PD Modification Application: MM 21-0556**Zoning Hearing Master Date:** September 13, 2021**BOCC Land Use Meeting Date:** November 9, 2021**Hillsborough
County Florida**

1.0 APPLICATION SUMMARY**Applicant:** Chestnut Hill Investments Five, LLC**FLU Category:** Suburban Mixed Use-6 (SMU-6)**Service Area:** Urban**Site Acreage:** 14.51 acres**Community
Plan Area:** Town N' Country**Overlay:** None**Introduction Summary:**

PD 18-1163 was approved in 2019 to allow for 72 single-family residential units. The applicant requests modifications to allow for a warehouse/distribution facility.

FIGURE 1
SIDEWALK IMPROVEMENTS

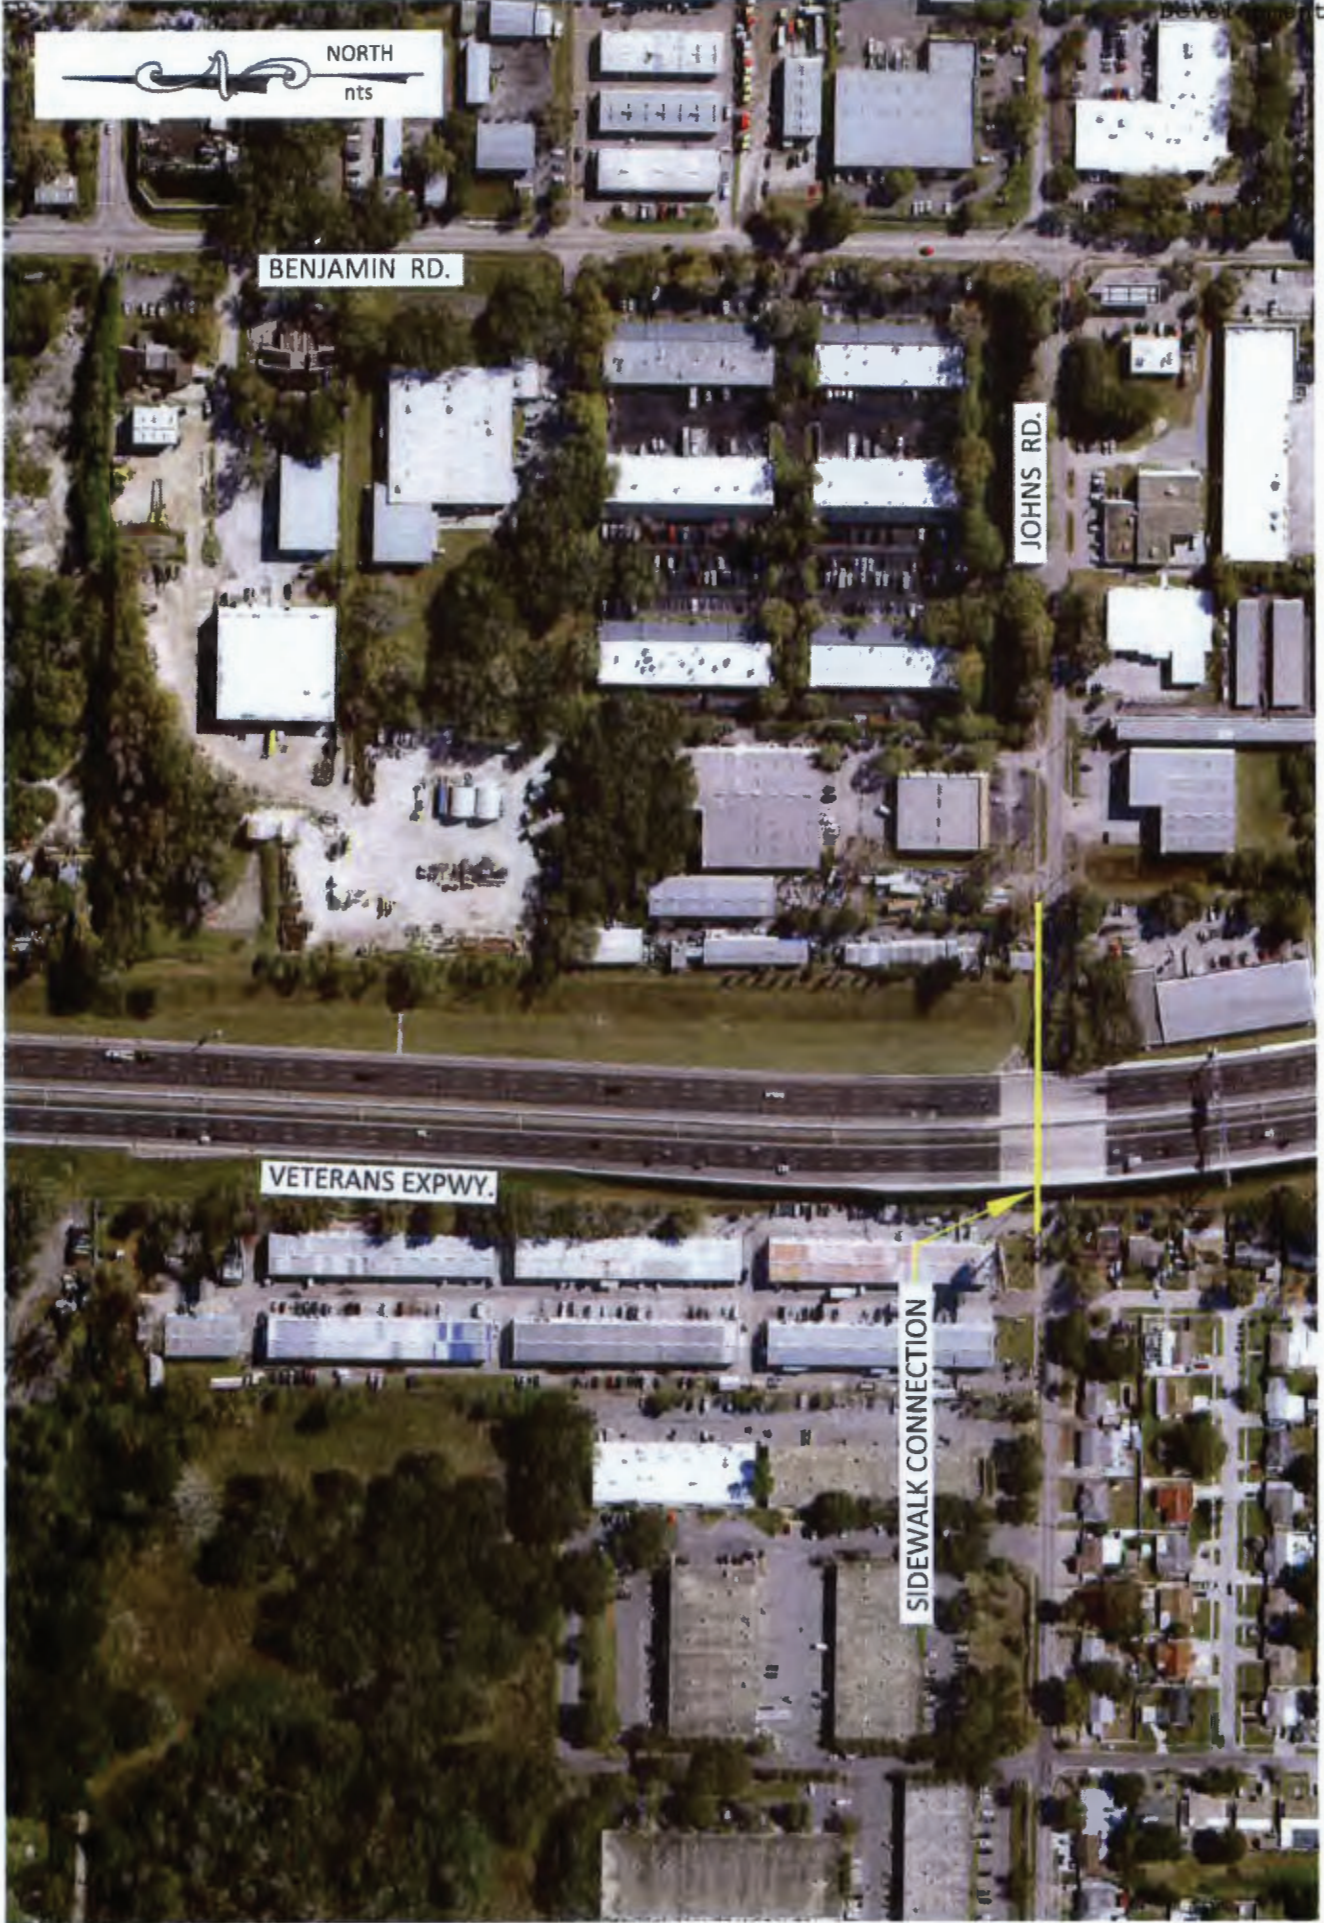
- 3) Sidewalk – TS-7 has 5 foot sidewalks on both sides of the roadway. The existing roadway has intermittent sidewalks along the subject section of Johns Road.

The developer proposes to construct the sidewalk gap as shown in Figure 1. This will provide continuous sidewalk on the northside of Johns Road from the project to Benjamin Road.
